INSTRUCTION TO SERVICE

ITS: 5851

SECTION:	350 Drivers Controls
WRITTEN BY:	Ken Chubaty
SUBJECT:	Replace old stock Smartrend Foot Switches with new stock (improved) Smartrend Foot Switches

Figure 3: Turn Signal Foot Switch Wiring

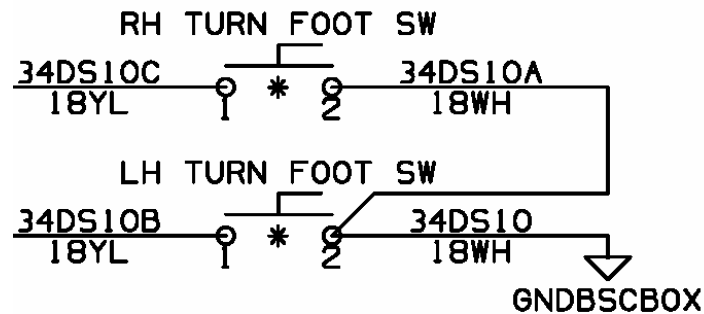
7. Check the part number stamp on the old and new parts, the Revision Level on the new part should be "Rev C."
8. Using the new switch (PN 5925959) which does have the Smartrend stamp on the side, install it in place of the old switch. The same hardware can be used.
9. Re-wire the switches with the existing wiring. See Figure 3 for reference.
